Thermal Discharge from the Toledo Edison Bayshore Power Plant: An Update

As a result of requirements included in its current National Pollutant Discharge Elimination System (NPDES) discharge permit, Toledo Edison conducted a "Thermal Mixing Zone Study" for the Bayshore Plant during the summer of 2002 which provided data about some of these issues. Data has also been collected by local governments and agencies for subjects such as bacteria and water temperature profiles. While the available information provides answers for some of the above assertions, there are remaining questions and the need for additional data. The relevant findings of the "Thermal Mixing Zone Study" and the conclusions of other data-gathering efforts are discussed below, as well as a description of the work which is continuing in order to address the outstanding issues.

Figure 2. Locations of Substrate Sampling in Maumee Bay

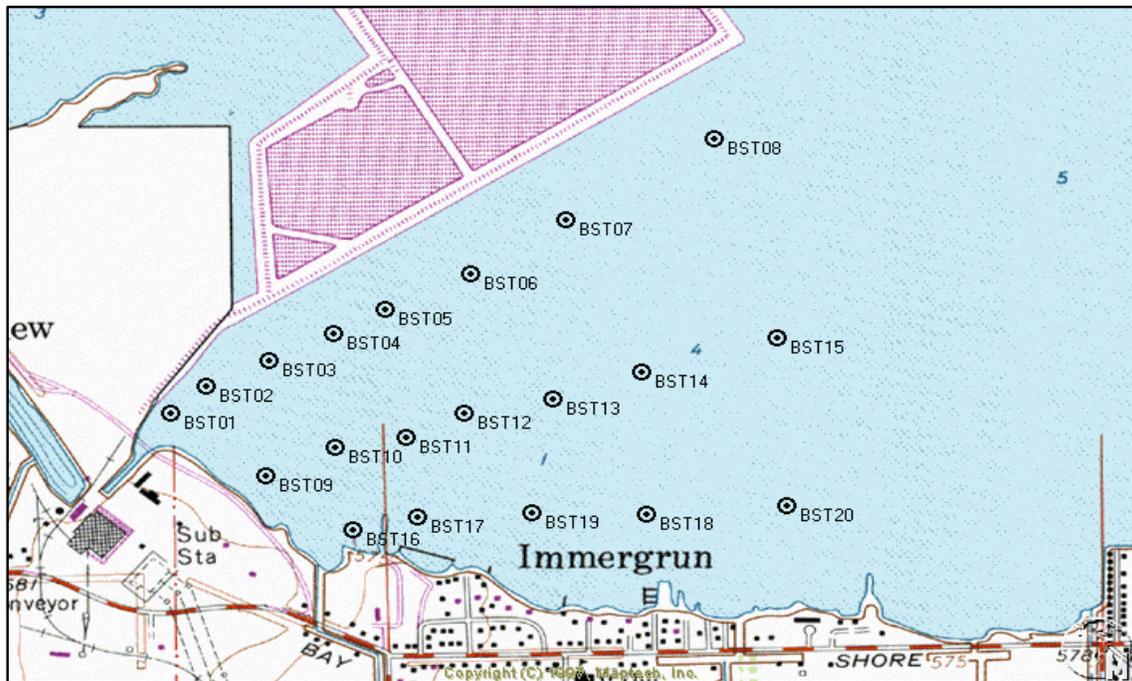
Table 1 below shows the characteristics of the substrate (or the material at the bottom) in Maumee Bay in the vicinity of the Bayshore Plant’s thermal discharge plume. Substrate samples were obtained during the summer of 2004. Locations of the sampling sites are shown on page 9 in Figure 2.

Based on bottom substrate grab samples collected during June and July 2004, it is apparent that the near-field thermal plume is resulting in the domination of the Asian clam *Corbicula*. Population densities of *Corbicula* increased at sites closest to the thermal discharge, and comprised the primary substrate at these sites. (See Table 1.)

Figure 5. Surface Temperature Contours for June 26, 2002 (in degrees Centigrade)

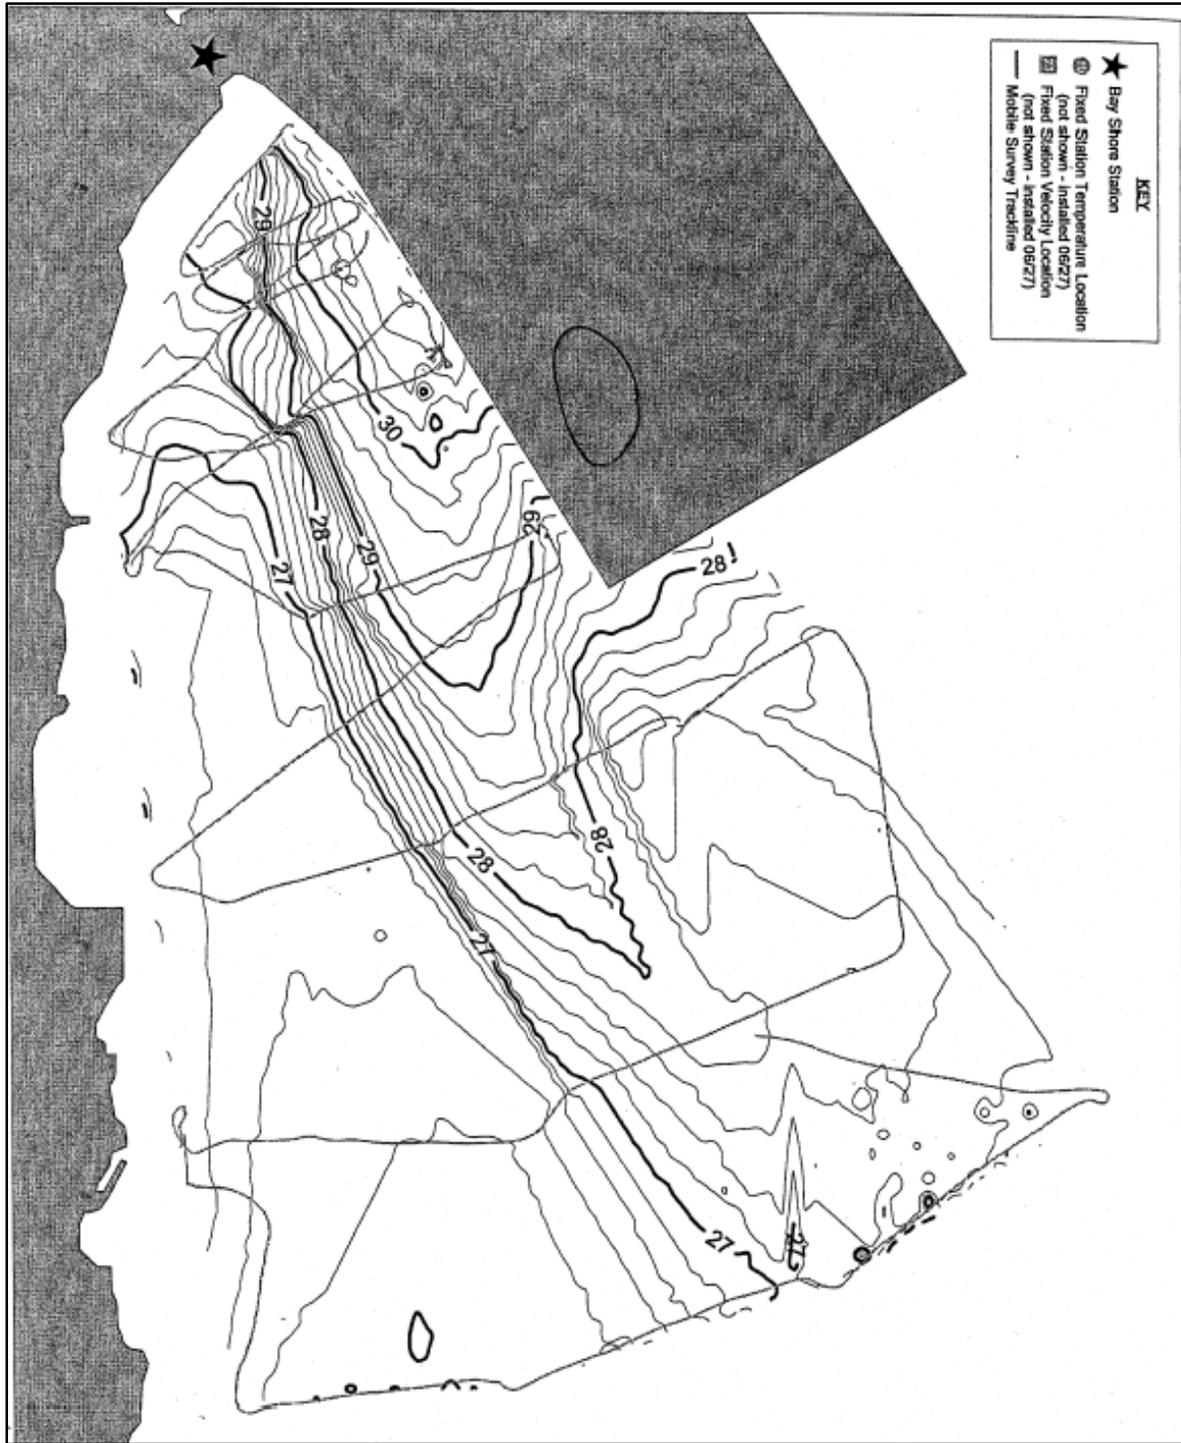
- Spatial distribution. The sampling performed during the summer of 2002 showed that the spatial distribution of the thermal plume is variable. On June 26th, the thermal plume extended in a northeasterly direction, parallel with the Confined Disposal Facility (CDF). (See Figure 5 in Attachment II.) On other occasions such as July 30th (Figure 7), the plume extended in a wider area to the south shore of Maumee Bay. At times, the plume also extended more than a mile beyond the end of the CDF. The spatial distribution of the thermal plume is undoubtedly affected by wind patterns and other phenomenon such as seiche effects (i.e., the naturally-occurring back and forth movement of water in Lake Erie and Maumee Bay, resulting in constantly changing water levels).
